# Access Compliance Report

## Public Rights-of-Way

Intersection ID: 30037	Main Street: MORNING_CREEK_LN	Cross Street: TWIN_ASH_CT	Location: S
ADA ID: 18CE9E05DB77	Ramp Type: PerpDiag	Initial Pass/Fail: Fail	Overall Compliance: No
		Severity Score: 8.75

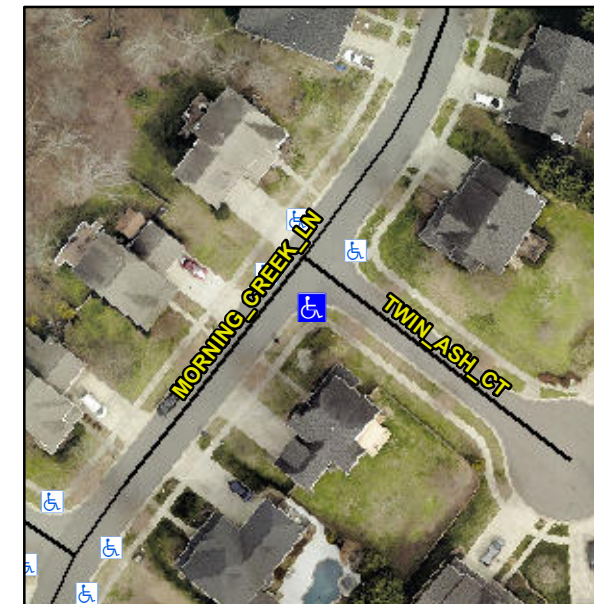
**Not Found, R304.5.1**

Compliance	Description	Data	Compliance	Description	Data
N/A	Ramp Length (in)	70.0	Yes	Ramp Slope (%)	5.0
No	Ramp Width (in)	45.0	Yes	Ramp XSlope (%)	1.0
N/A	Flare Type LT	N/A	N/A	Flare Type RT	N/A
N/A	Flare Slope LT (%)	N/A	N/A	Flare Slope RT (%)	N/A
N/A	Flare Traversable LT?	N/A	N/A	Flare Traversable RT?	N/A
N/A	Landing Length (in)	N/A	N/A	DWS Provided?	N/A
N/A	Landing Width (in)	N/A	N/A	DWS Contrast?	N/A
N/A	Landing Slope (%)	N/A	N/A	DWS Length (in)	N/A
N/A	Landing X Slope (%)	N/A	N/A	DWS Full Width?	N/A
N/A	Landing Curb? (Y/N)	N/A	N/A	DWS Offset (in)	N/A
N/A	Shared Landing?	N/A			
N/A	Gutter Ponding?	N/A	N/A	Gutter Slope (%)	N/A
N/A	Gutter Lip Ht (in)	N/A	N/A	Gutter X Slope (%)	N/A
N/A	Painted X Walk1?	No	N/A	Painted X Walk2?	No
	X Walk 1 Direction	To NE		X Walk 2 Direction	To NW
N/A	X Walk 1 Width (in)	N/A	N/A	X Walk 2 Width (in)	N/A
	X Walk 1 Slope (%)	2.0		X Walk 2 Slope (%)	4.0
	X Walk 1 X Slope (%)	2.6		X Walk 2 X Slope (%)	2.7

**Remove & Replace Curb Ramp With Two New Directional Ramps or Equivalent.**
